ADDENDUM
NO. 1

July 16, 2020

Additions & Renovations to Lawrence North High School
7802 Hague Road
Indianapolis, IN 46256

PREPARED BY SCHMIDT ASSOCIATES FOR:
LAWRENCE NORTH HIGH SCHOOL RENOVATION
LAWRENCE TOWNSHIP, M.S.D. OF

HHH. **Drawing Number MP1G2**

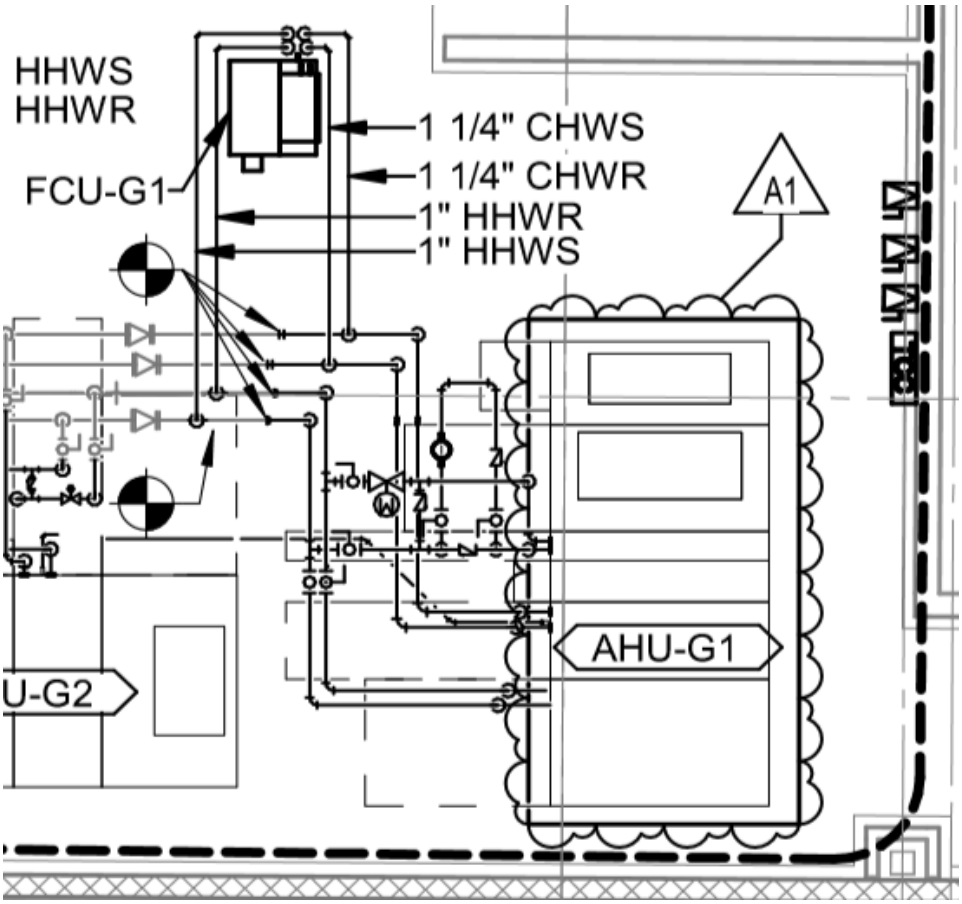
1. MODIFY drawing to show pipe routing as follows:

LLL. **Drawing Number MP1J1**

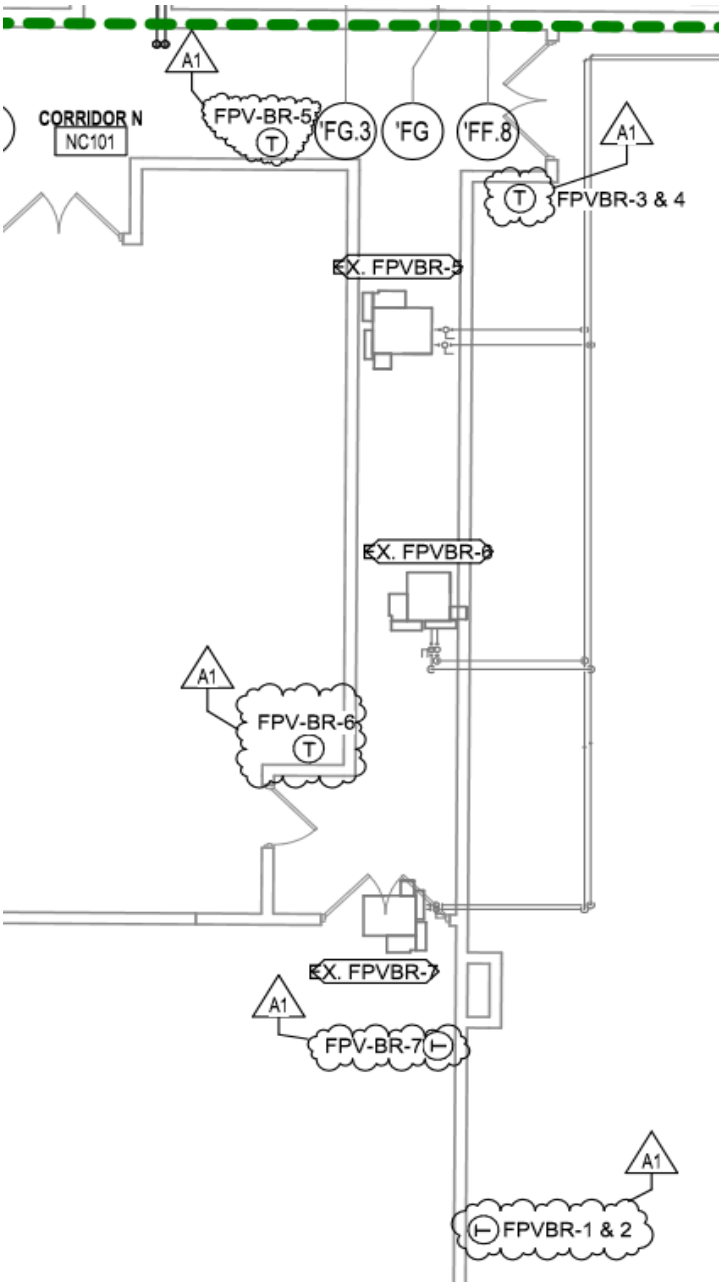
1. MODIFY drawing to show location of new thermostat as follows:

SSS. **Drawing Number M-402**

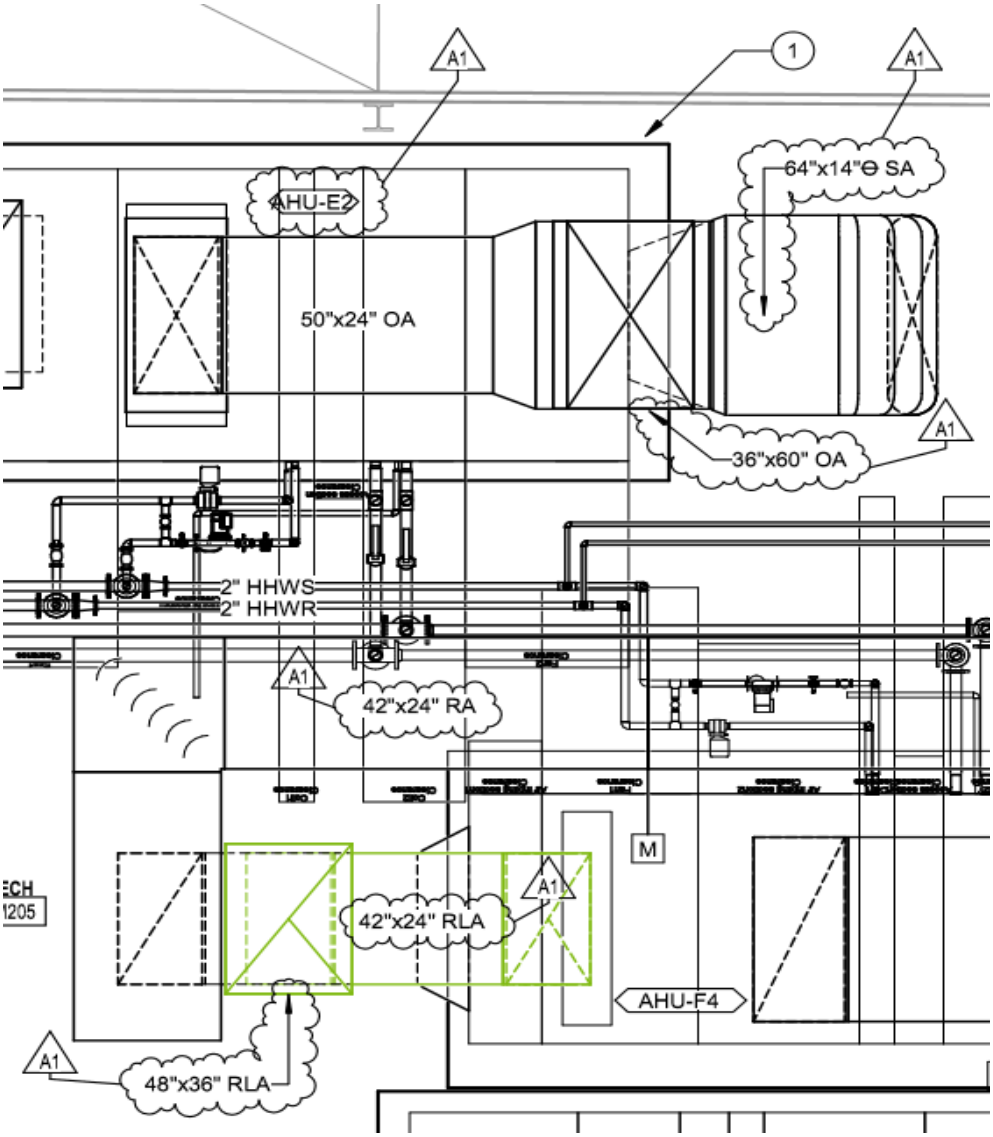
1. MODIFY drawing to show duct routing & sizes as follows:

TTT. **Drawing Number M-402**

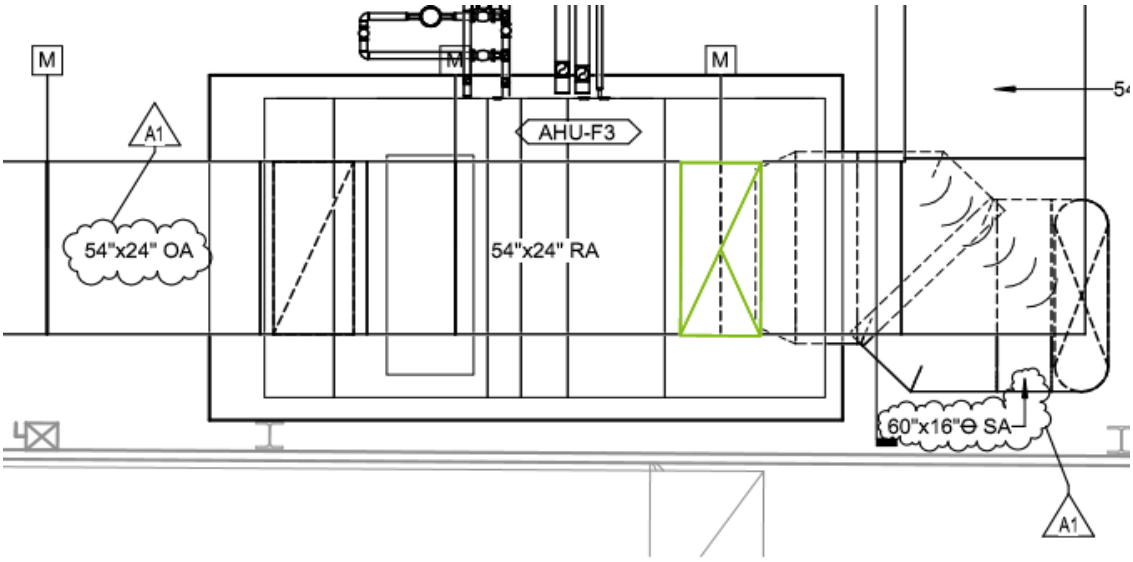
1. MODIFY drawing to show piping size and modifications as follows:

UUU. **Drawing Number M-404**

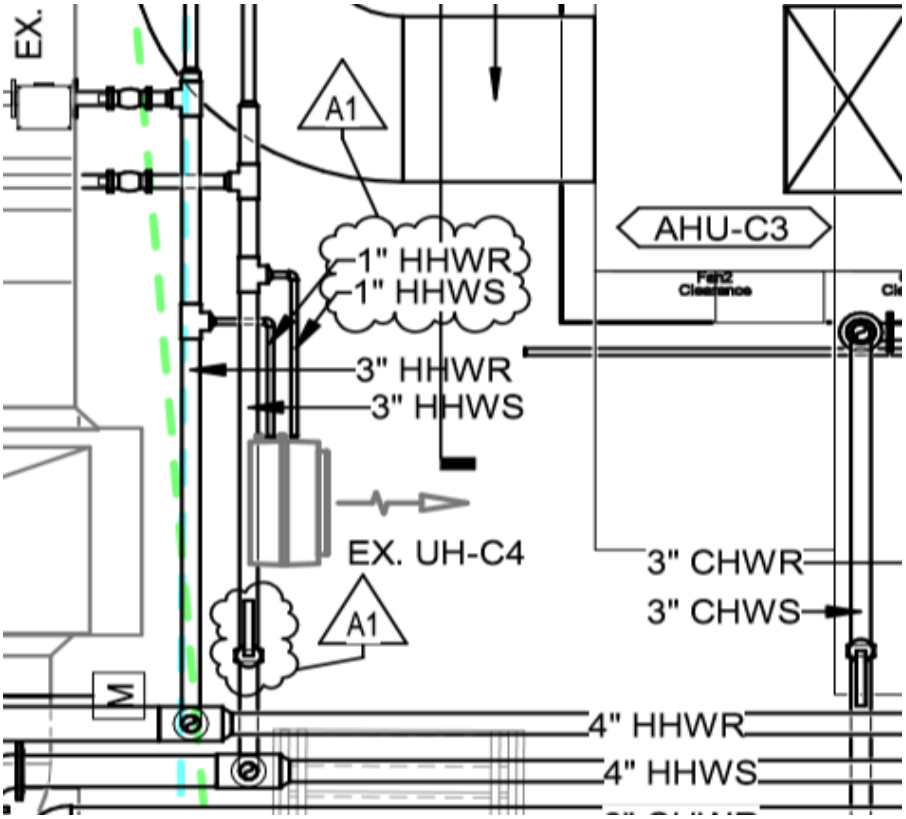
1. MODIFY drawing to show duct routing & size as follows:

VVV. **Drawing Number M-404**

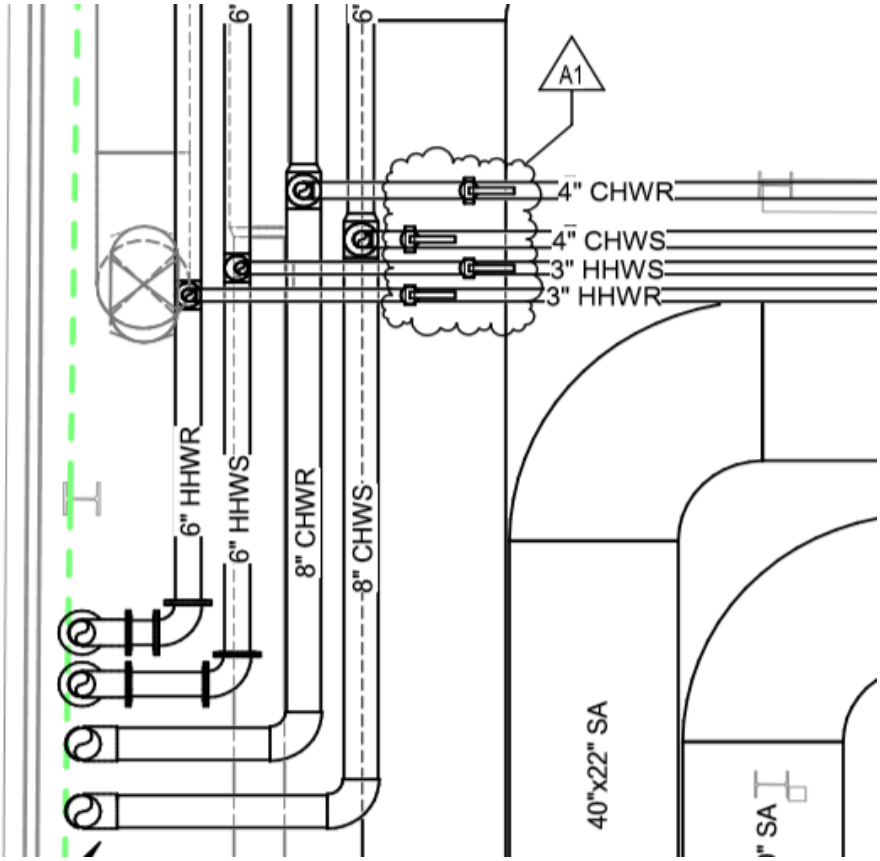
1. MODIFY drawing to show shut off valve location as follows:

WWW. **Drawing Number M-404**

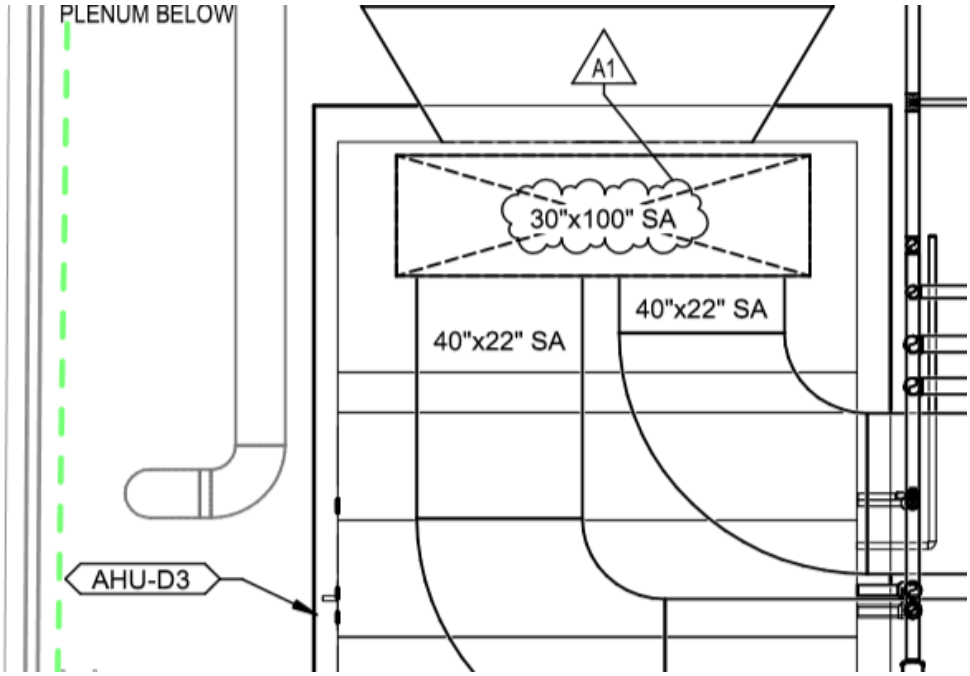
1. MODIFY drawing to show duct size as follows:

5C NEW AND EXISTING BOILER PIPING DETAIL TYPICAL OF 7 BOILERS
NOT TO SCALE

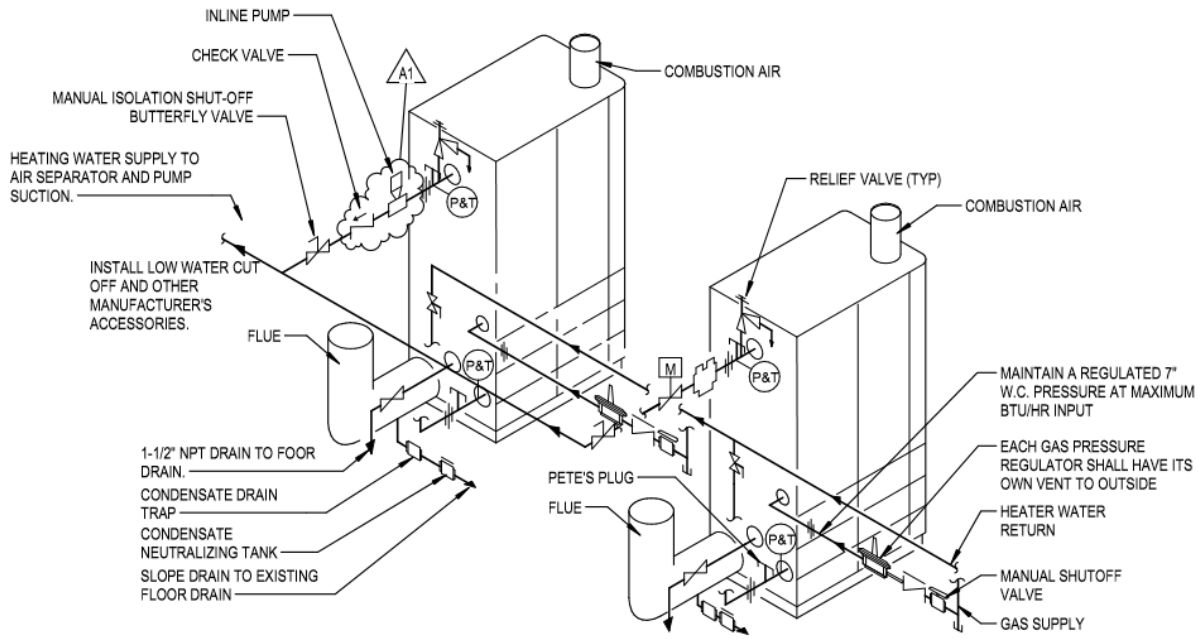
1. MODIFY detail to addition of boiler circulation pump as follows. Typical of all new & existing boilers:

D. **Drawing Number PF1F0**

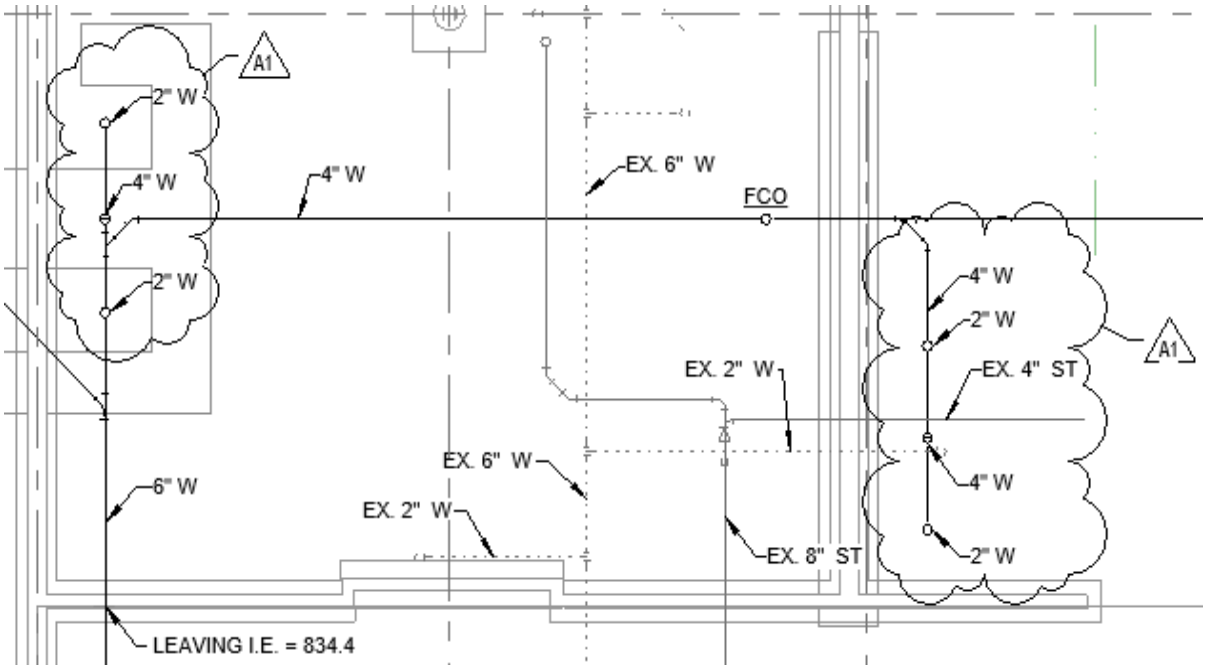
1. MODIFY Drawing to show floor drain waste piping as follows:

H. **Drawing Number PP1H1**

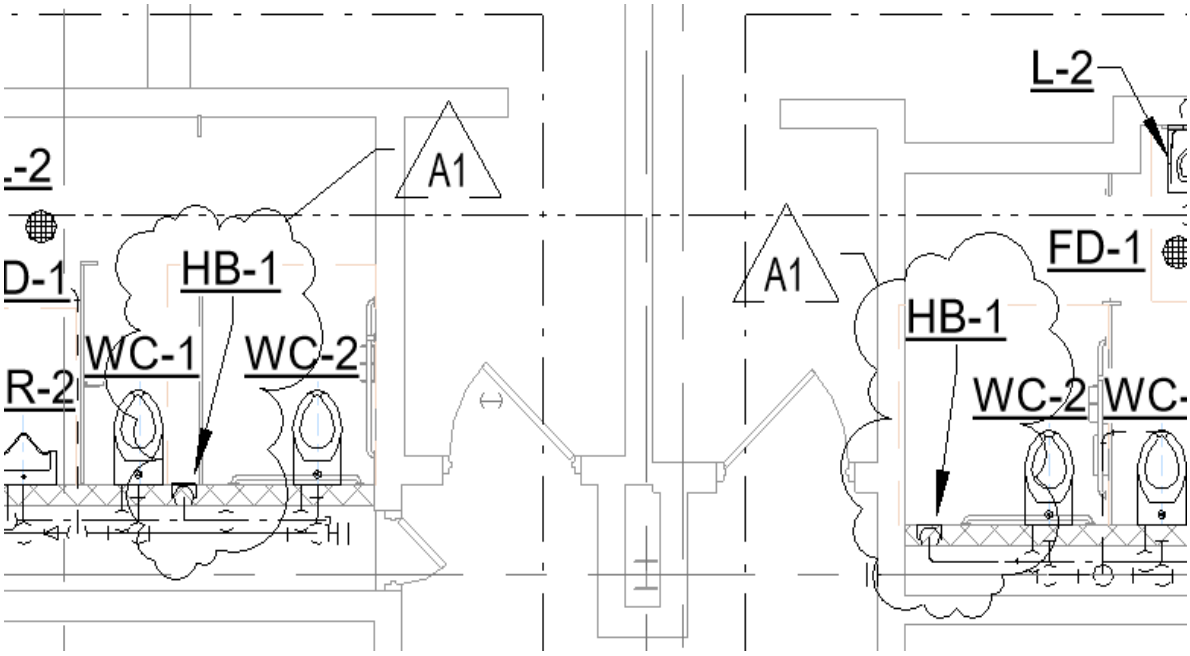
1. MODIFY Drawing to show HB-1 and piping as follows:

I. **Drawing Number ED1K1.**

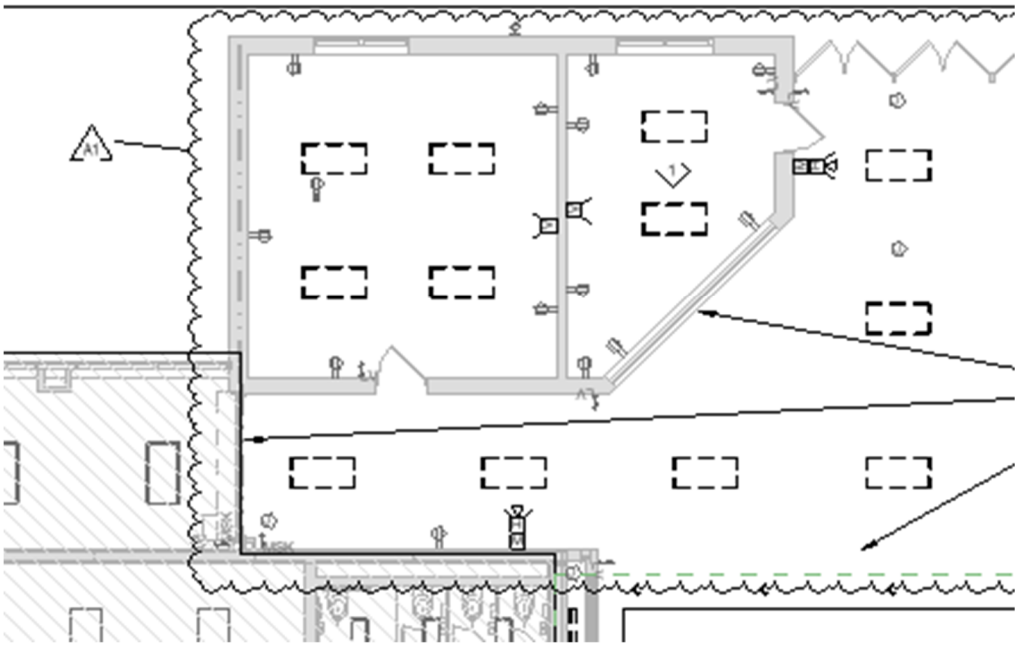
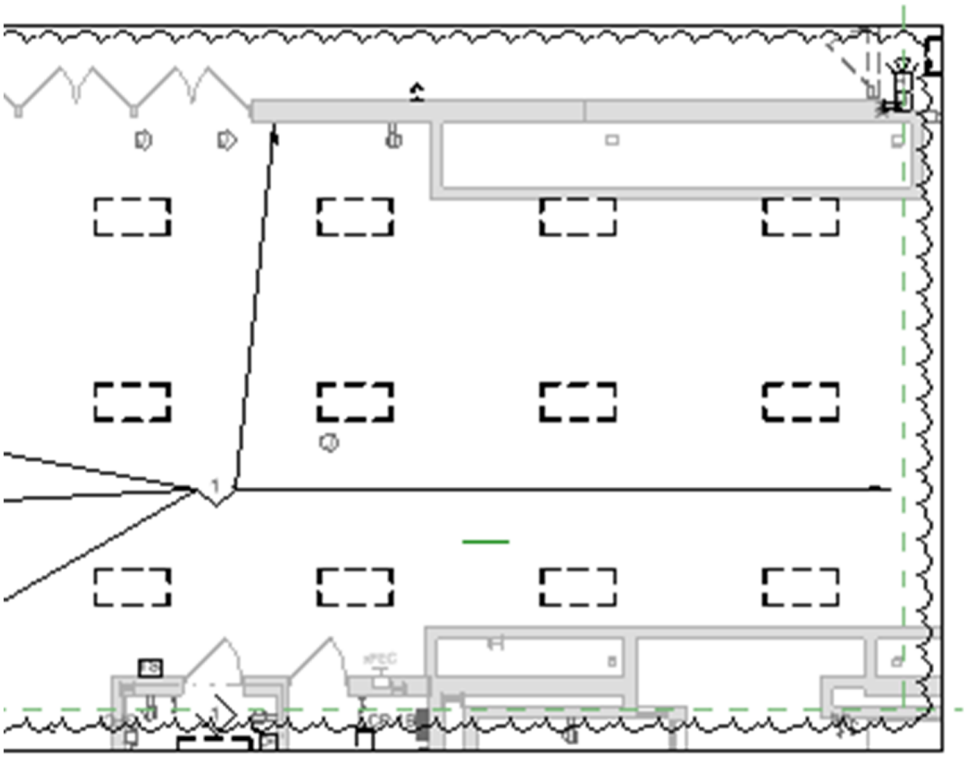
1. ADD Partial Plan to Unit K as follows:
